Docket Olympic View Water & Sewer District Motion 21-289 (ECAF 21-0633)

MOTION 21-289

CONCERNING APPROVAL OF THE 2007 OLYMPIC VIEW WATER AND SEWER DISTRICT COMPREHENSIVE SEWER PLAN AMENDMENT NO. 2, AUGUST 2019

2007 COMPREHENSIVE SEWER PLAN AMENDMENT NO. 2 Appendix H: Southwest Sewer Service Area System Improvements

Figure 1
Olympic View Water & Sewer District Overview

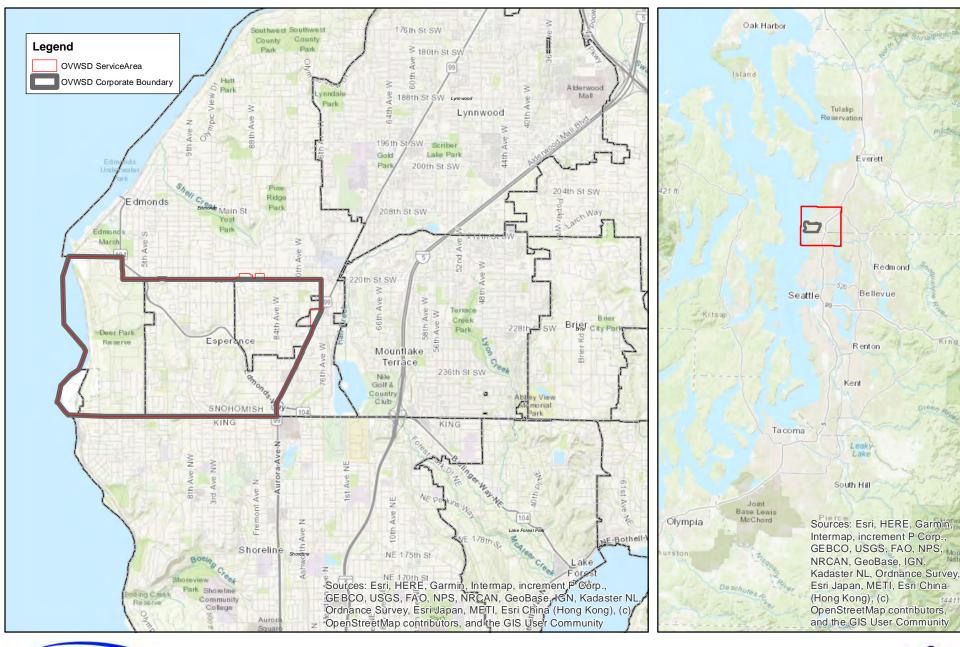
7	Figure 1 - This figure and/or supporting text should clarify that the Amendment establishes a new sewer service area boundary within the SSSA by expanding OVWSD's sewer service area to incorporate the Point Wells area that is currently served by RWD.	This figure does not establish or expand Olympic View WSD's sewer service area boundary. The area shown in this figure is within Olympic View WSD's existing boundary as approved in 1967 when the sewer system was approved.
	8	Figure 3: Re-label Forest Glen LS	Figure 3 has been revised to label the Forest Glen Lift Station.
	9	Page 11: Please clarify paragraph ending at top of page (last 3 sentences).	This paragraph has been revised.
